COUNCIL PUBLIC HEARING

1. Appeal of Planning Commission's Denial of a 46-Lot Planned Development Subdivision Preliminary Plat located SE of the Intersection of Pittsburg Road and Meadowview Drive (Comstock)

CITY OF ST. HELENS PLANNING DEPARTMENT STAFF REPORT

Appeal AP.2.22 (of Subdivision Preliminary Plat, SUB.2.22)

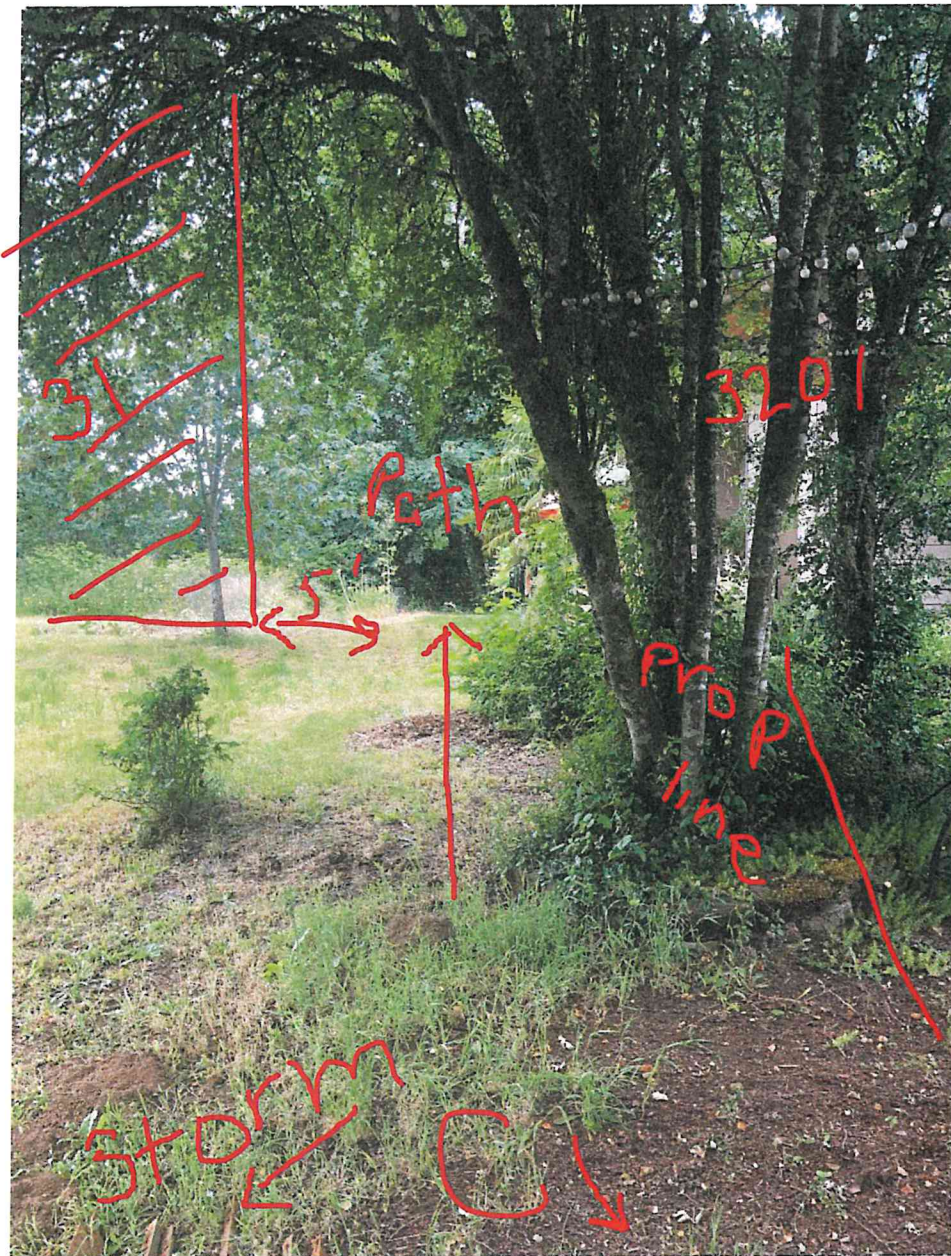
Lastly as a general inquiry regarding the creation of South Lane (middle & south) map. Currently Parcel 1, which includes 3 tax lots, accesses the residences directly from Barr Avenue via a private driveway. The new right of way creating a public access road will change the residential access via the easement driveway from Barr to the newly named South Lane. Does the city expect this to affect the mailing addresses of the existing 3 residences of Parcel 1? Removal of the mailbox for the three residences will be removed from Barr Ave. during the creation of the new road. What is the expectation for the homeowners in Parcel 1 regarding mail delivery during construction and reinstallation of the mailboxes post construction?

A. Wildlife currently traveling from Storm C to Open Area south end flanking Parcel 1

B. Storm C off of Barr Ave. flanking Parcel 1, Existing trees on property line

C. Proposed wildlife pathway,
retains existing trees

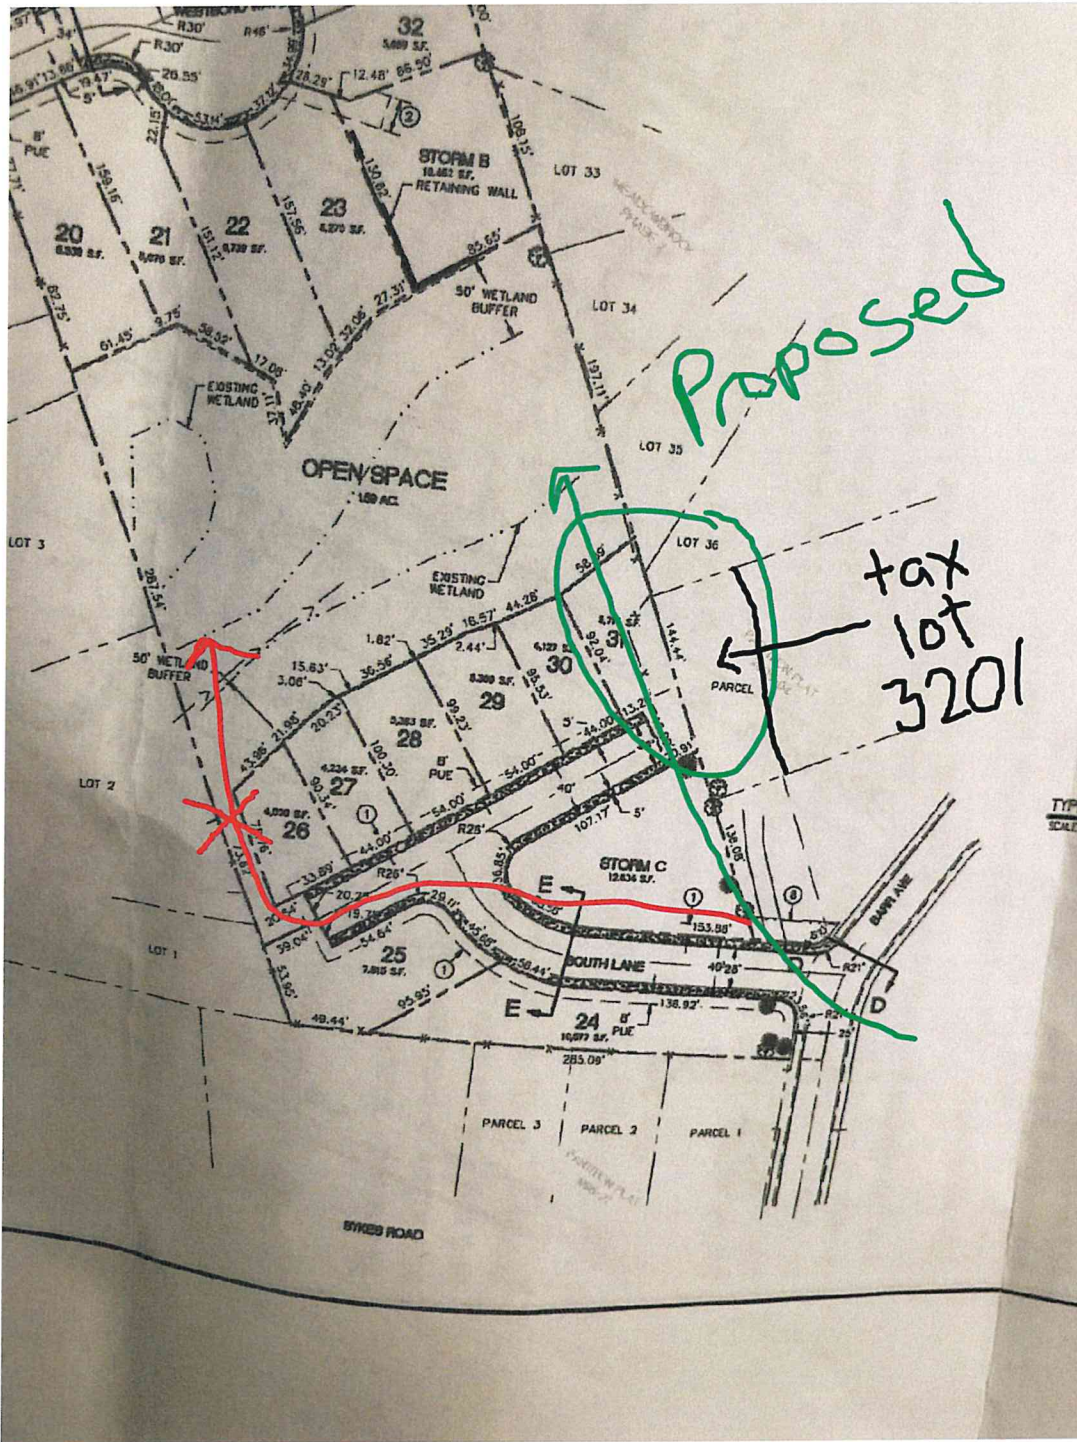
**D. Swap path from
Lot 26 over to Lot
31**

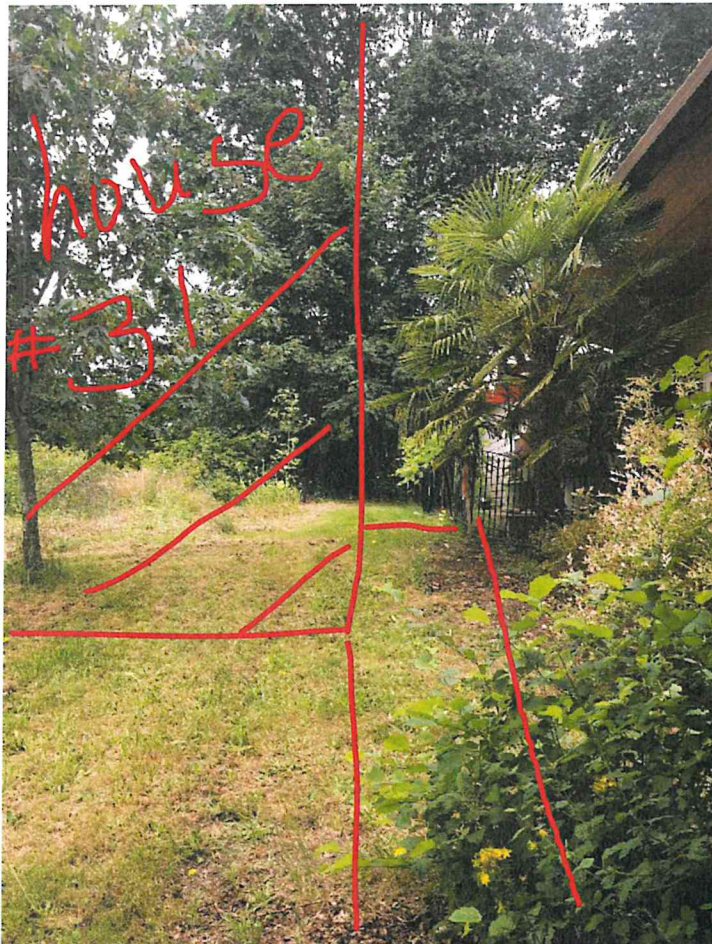
E. Side of Lot 31 will have a significant effect on privacy of Parcel 1, tax lot 3201. Adding wildlife pathway will increase perception of distance between side setback

F. Side of Lot 31 will have a significant effect on privacy of Parcel 1, tax lot 3201. Adding wildlife pathway will increase perception of distance between side setback
